**COUNCIL ACTION FORM**

**SUBJECT: SOMERSET SUBDIVISION 25<sup>TH</sup> ADDITION – PRELIMINARY PLAT / MAJOR SITE DEVELOPMENT PLAN REVISION**

**COMMISSION ACTION FORM**

**REQUEST:** Preliminary Plat/Major Site Development Plan revision for Somerset Subdivision 25<sup>th</sup> Addition

PROJECT NO.  
 5000-12R  
 SHEET  
**A.02**

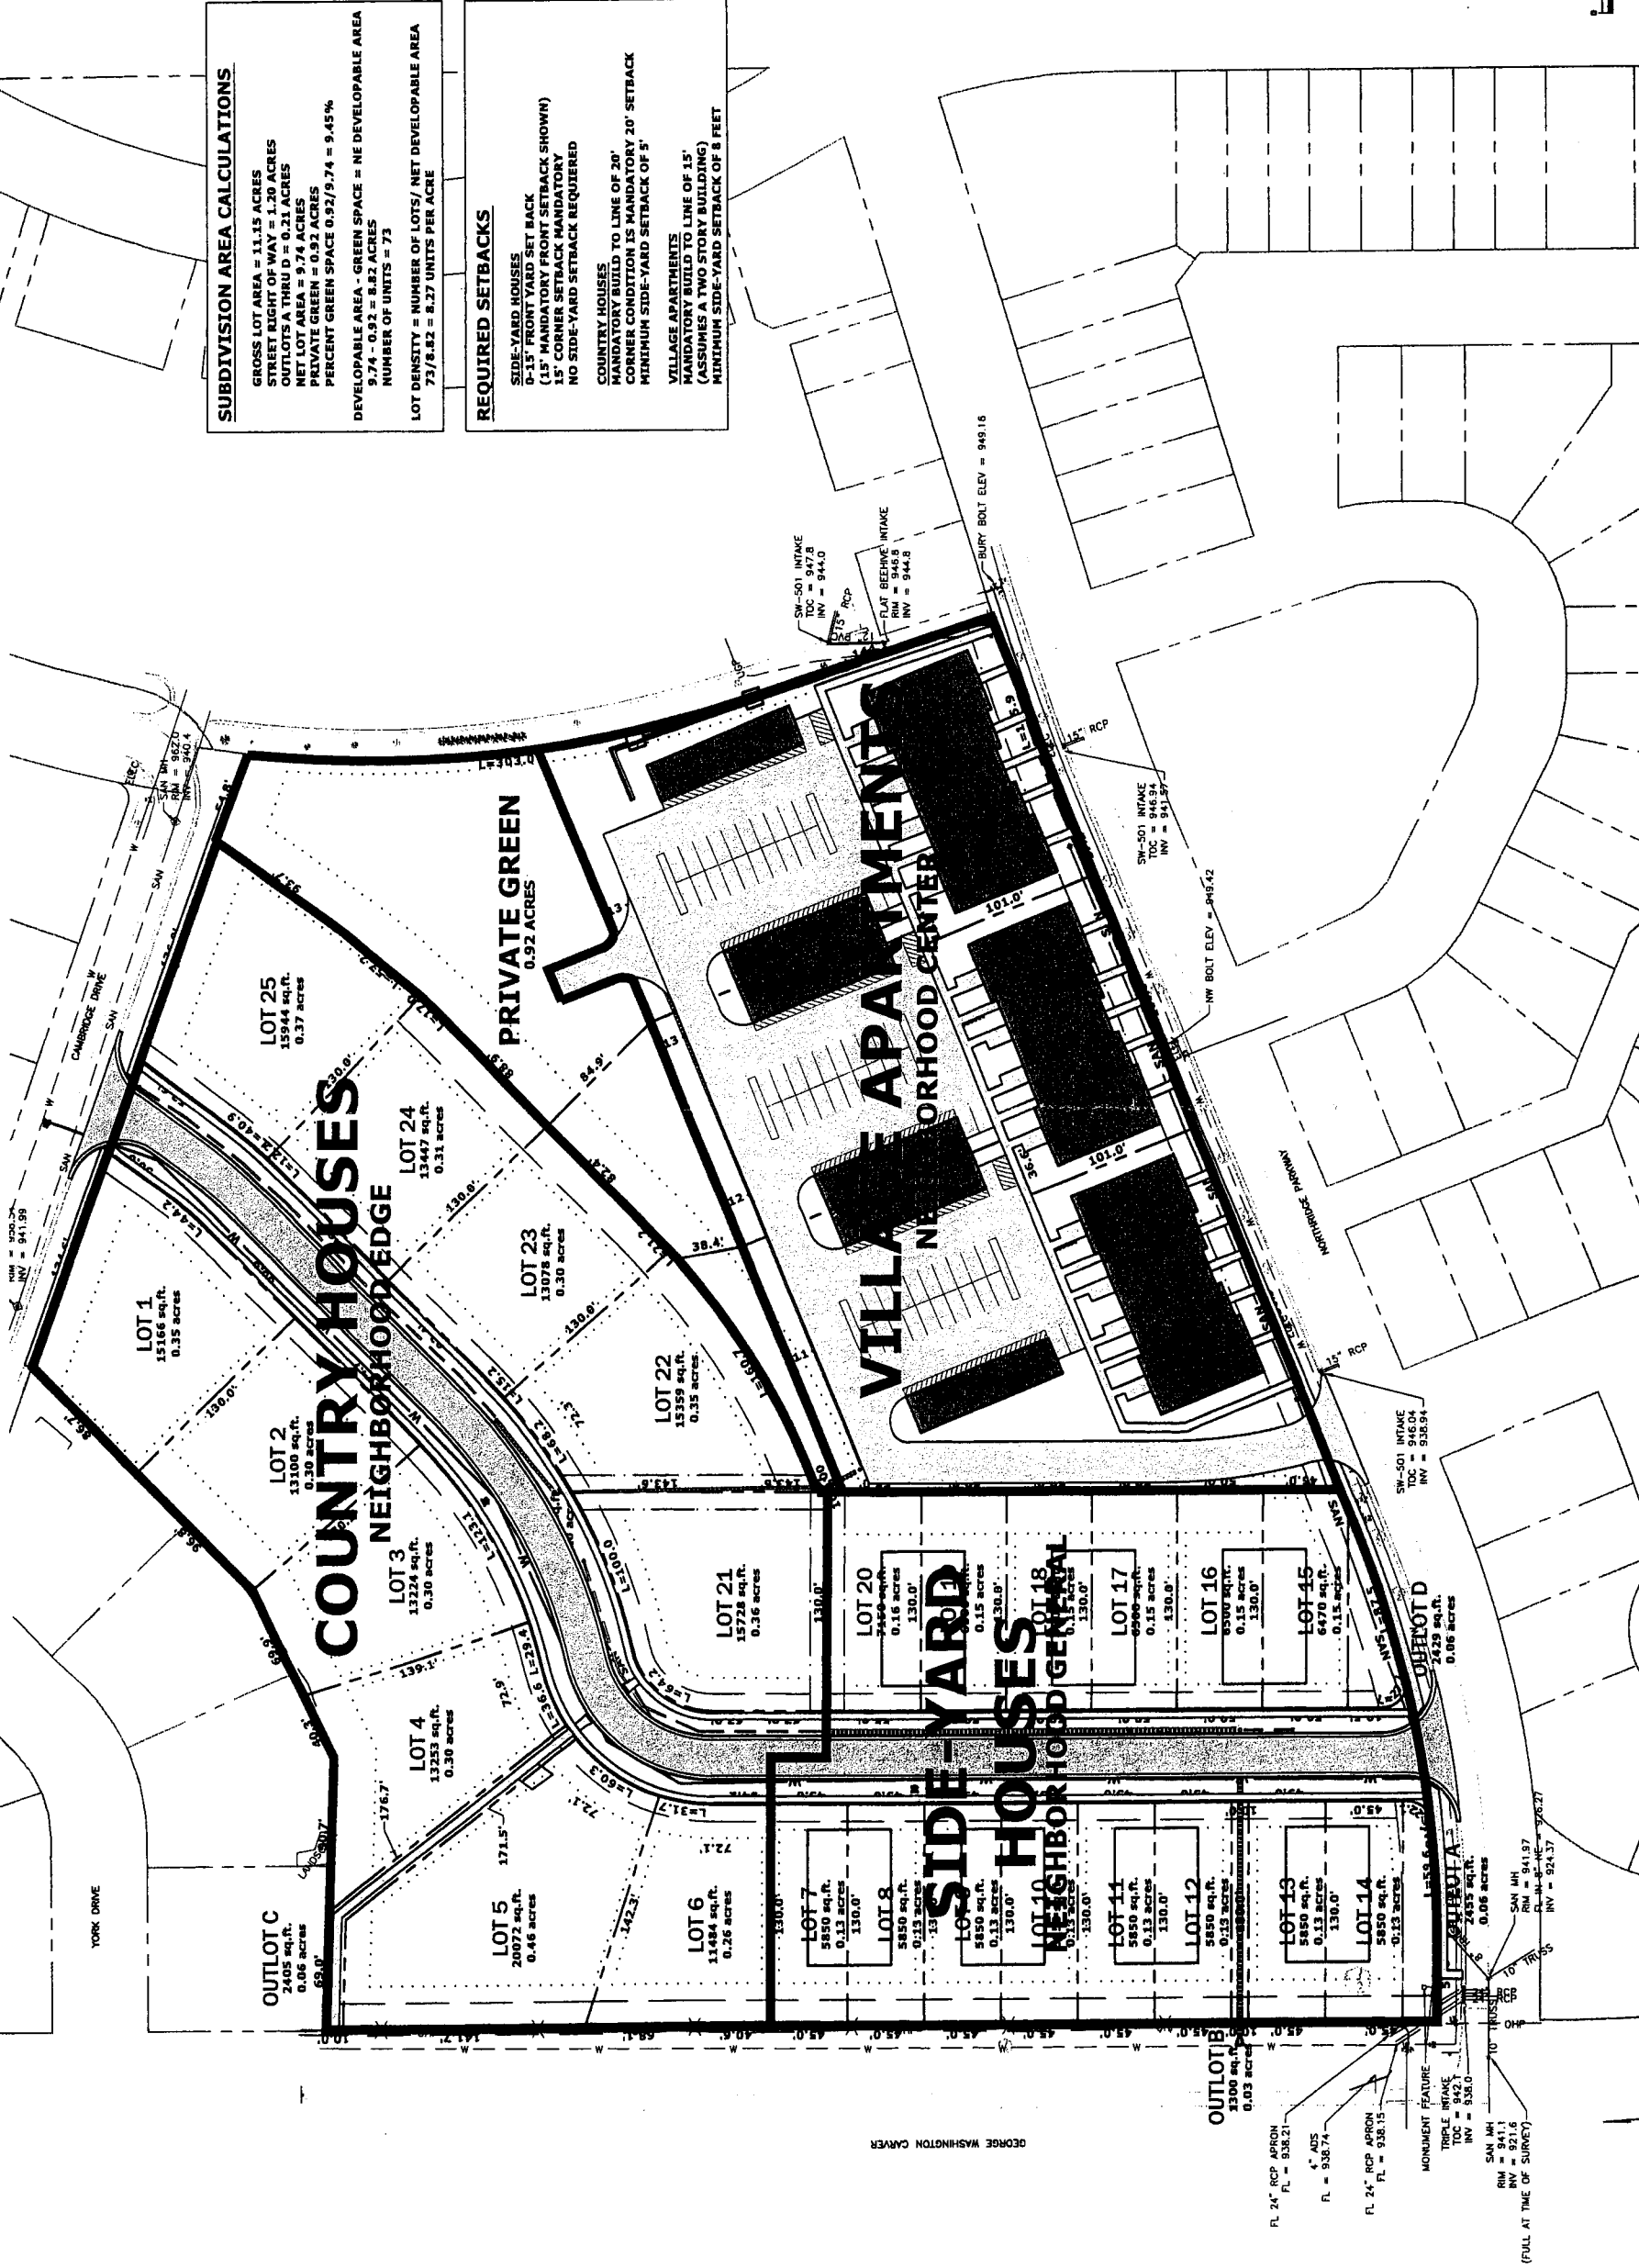
The design of the built up portions of Somerset met the following design principles and the Plan does not change what is already there. The Plan includes a new, small private green space between the Village Apartments and the Country Houses. (See attached Floating Zone Uses, Sheet A.02 of proposed plans)

Floating Zone Uses, Sheet A.02 of proposed plans (attached) coordinates the permitted uses with the Neighborhood areas in conformance with Ames *Municipal Code* Table 29.1201(5).

The standards for Land Use Density/Intensity require residential uses to be developed at a net density of at least 8 units per acre. The calculation on Floating Zone Uses, Sheet A.02 of the proposed plan, documents that the net density of the subject site will

be 8.27 dwelling units per net acre. With the net area of the subject site added to the previous net area of residential uses throughout Somerset, the total residential component of the project will be 934 dwelling units at a net density of 9 dwelling units per acre.

PROJECT NO.  
5000-12R  
SHEET  
D.02

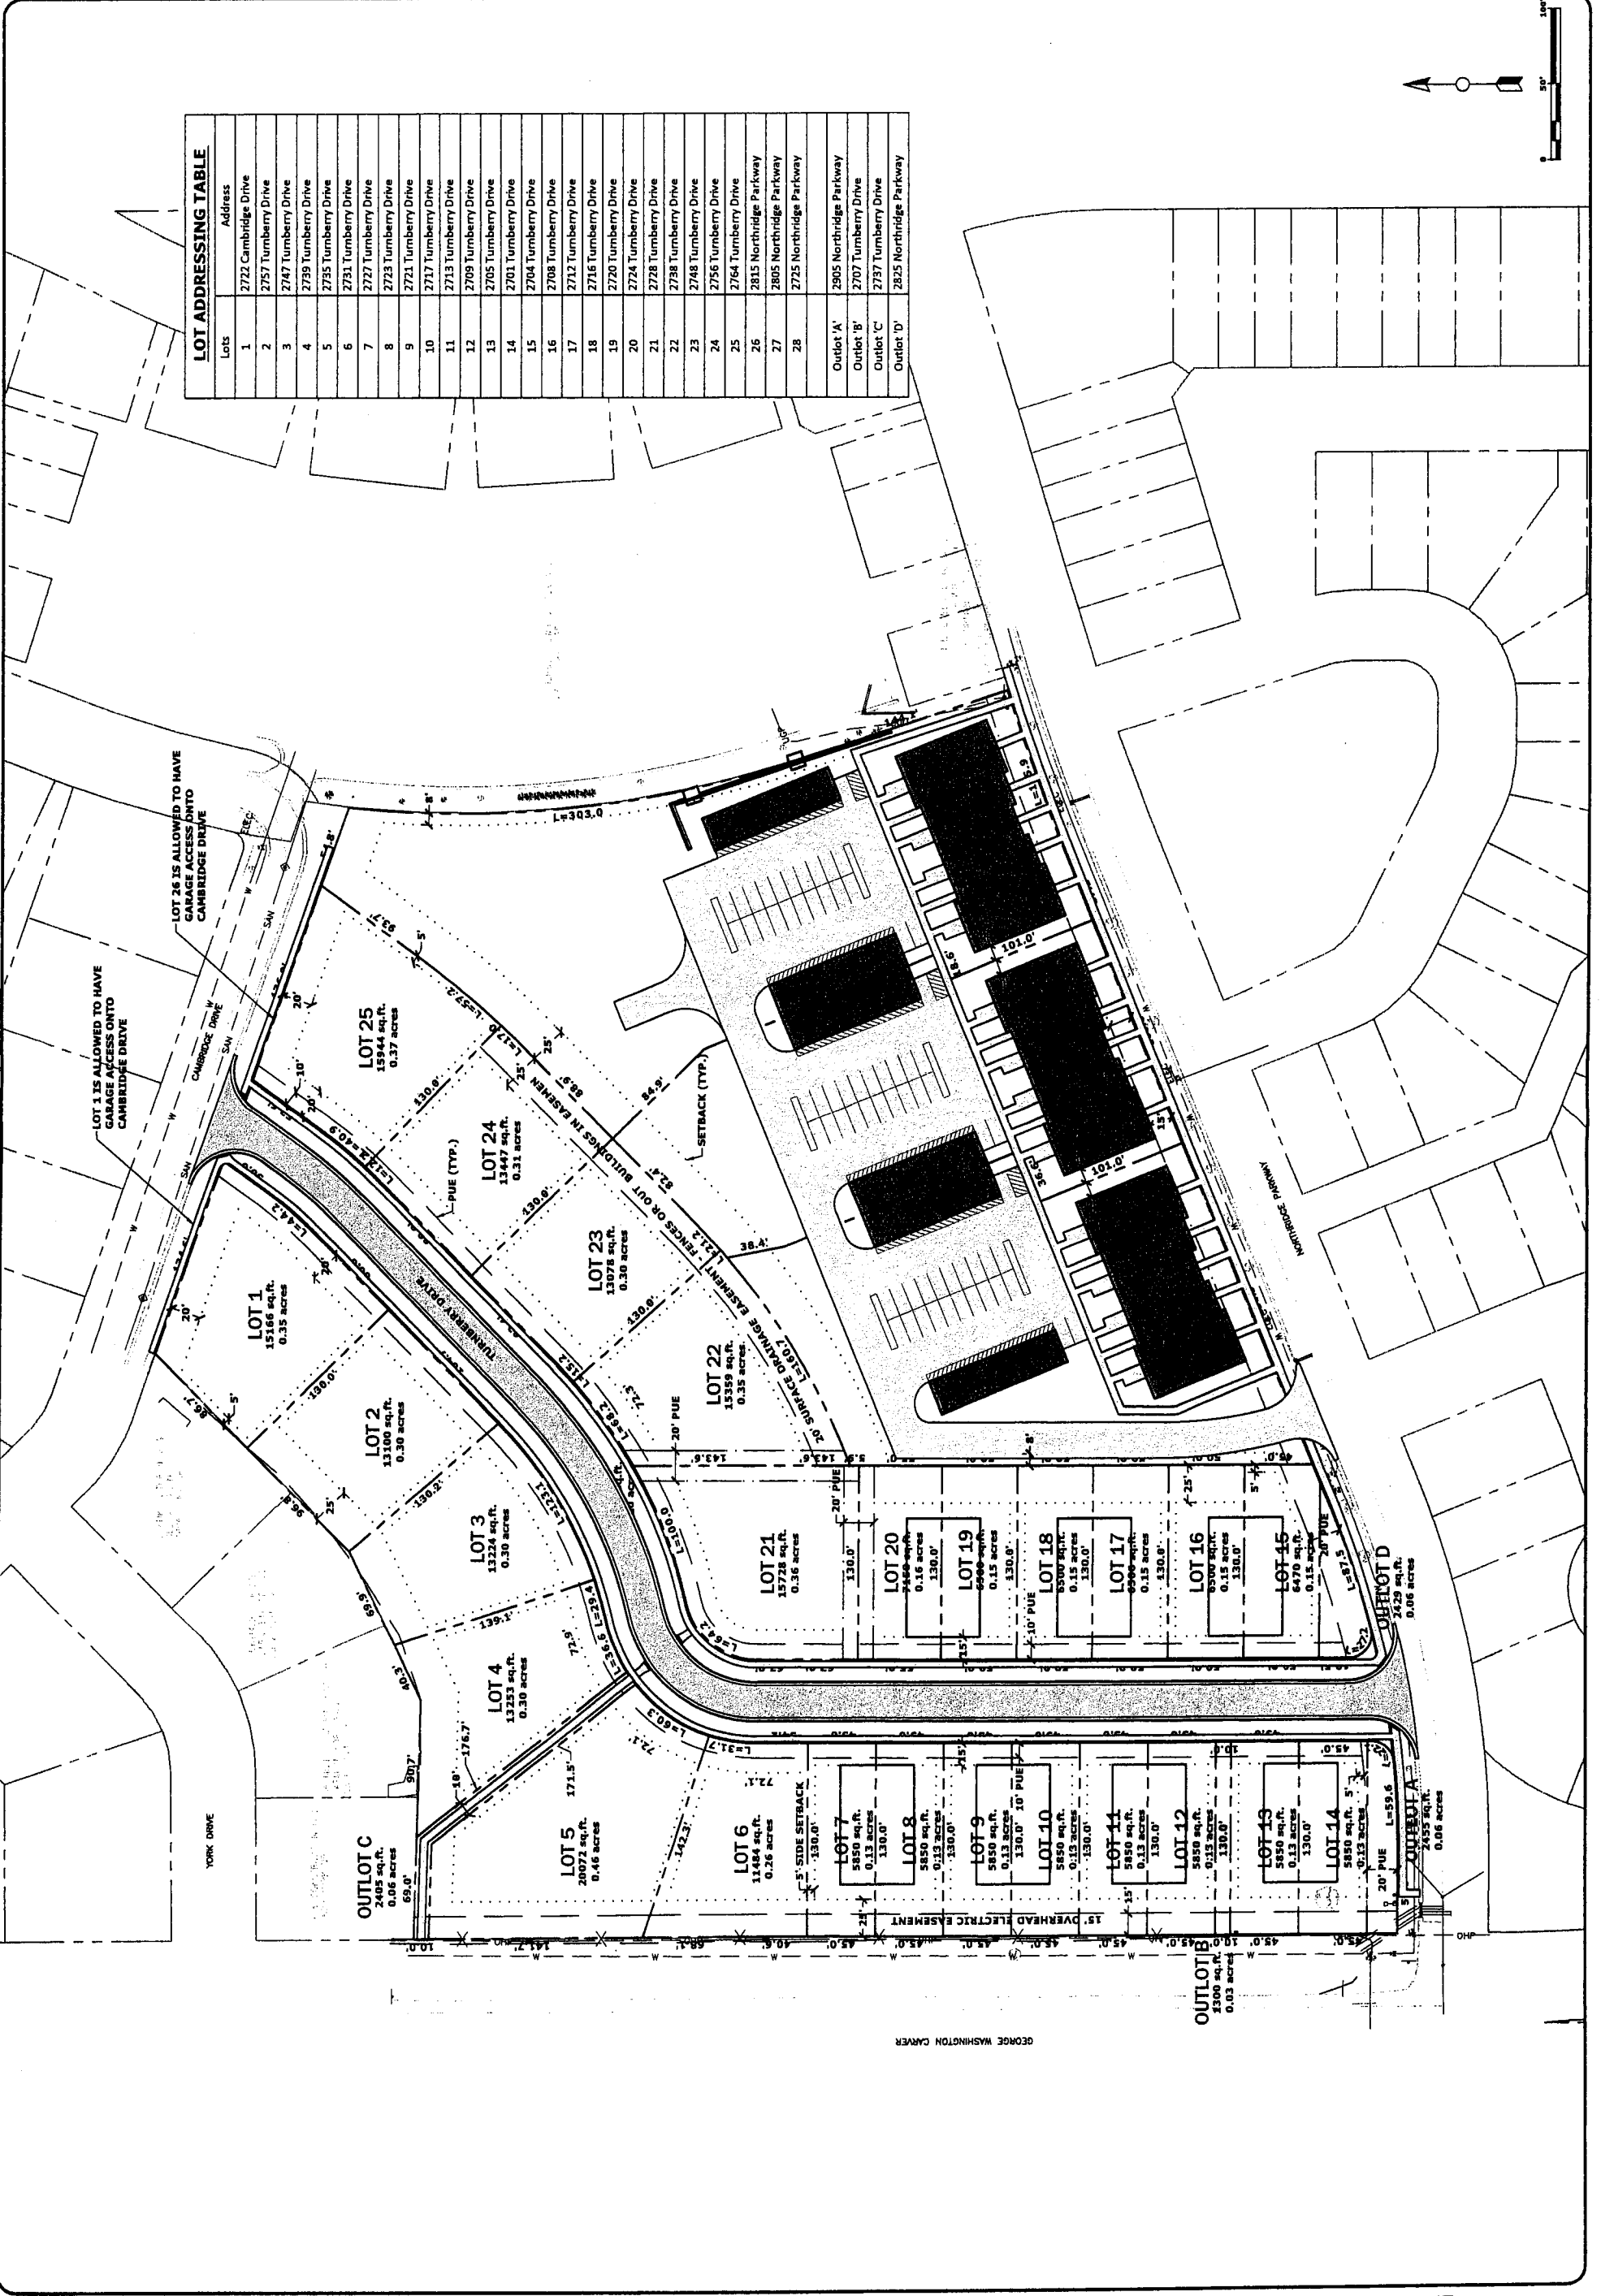
To serve the three Village Apartments, an 8-inch sanitary sewer is to be installed within a 20-foot wide public utility easement to the north of Northridge Parkway. (See Dimension Plan, Sheet D.02 of proposed plans. Also shown on Northridge Parkway Sanitary Extension, Sheet D.07 of proposed plans, available on request.)

Staff has determined that the proposed Plan conforms to the Lot and Block Design standards, with two exceptions. Blocks longer than 660 feet in length are not to be created. Turnberry Drive is 1000 feet in length, exceeding this standard. It should be noted, however, that another cross street is not possible in this area because of the existing commercial area to the east and George W. Carver Avenue to the west. The traffic volume on George W. Carver Avenue and the proximity to other cross street intersections prevent access to this site from the west. Therefore, application has been made for a variance from this zoning standard.

1. A variance is approved for the proposed public street with a length in excess of that allowed by the Village Residential Supplemental Development Standards
2. The existing approved Preliminary Plat/Major Site Development Plan for the Somerset Village is revised to incorporate the proposed Plan amendments before a Final Plat is approved for the 25<sup>th</sup> Addition.
